American Telecommunications Certification Body Inc.  
6731 Whittier Ave, McLean, VA 22101

RE: Palmone Inc.

FCC ID: O8FJIMI

After a review of the submitted information, I have a few comments on the above referenced Application.

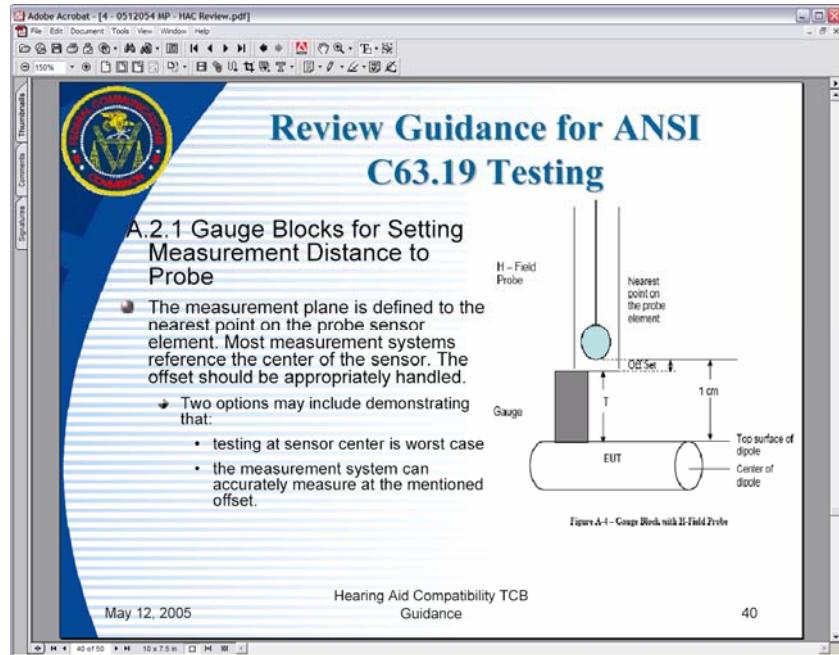
- 16) RF test procedures appear to be for clause 4, but the flow chart appears to be for Hearing aides. Please review/explain/correct as necessary.
- 17) Scan procedures do not support enough detail. For instance the procedures should clarify the information shown in the slide below from FCC training. Additionally, the contours on many plots suggest that maybe a smaller step size should have been used. Please adjust the test report or comment on the items given in the follow slide:

- Description of scan procedures, including step size, locations relative to the measurement grid, and peak location determination.
- Step size should be justified and not exceed 5 mm. Uncertainty evaluation concerns should be reviewed to see if smaller step sizes are necessary.
- Consider spanning grid line to avoid question with shared values on grid lines e.g. 3.334 mm.
- Contour plots should be reviewed and demonstrate that finer step size would not be required.
  - ◆ Peaks should be clearly defined and of a dimension (e.g. 3 dB width) much greater than the step size.

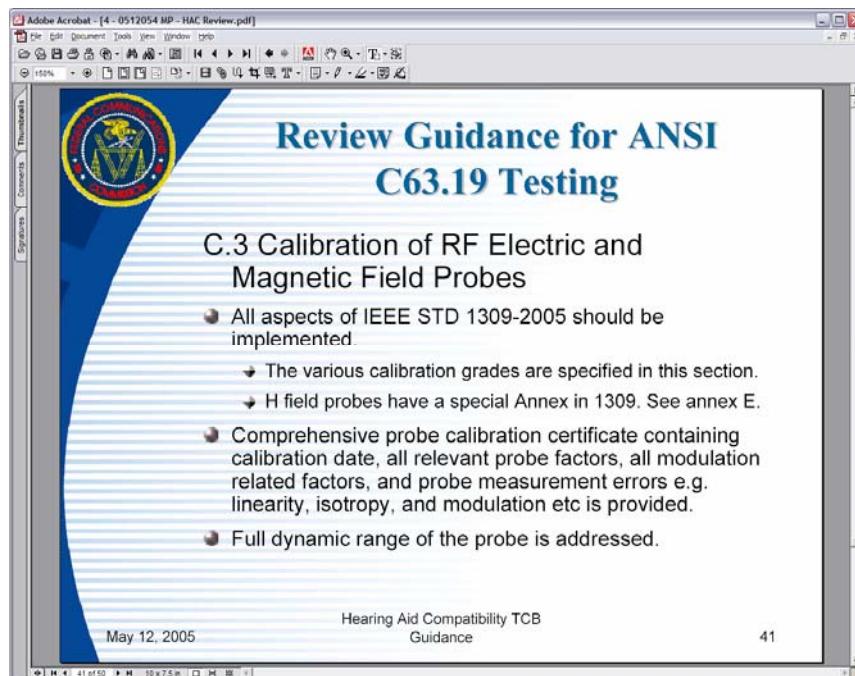
18) Please justify probe measurement at the center of the sensor. C63.19 recommends measurement at the nearest element point. Please include additional illustrations of the probe/elements showing more detail of the probe tip area. This is for compliance of information shown in the following slide:
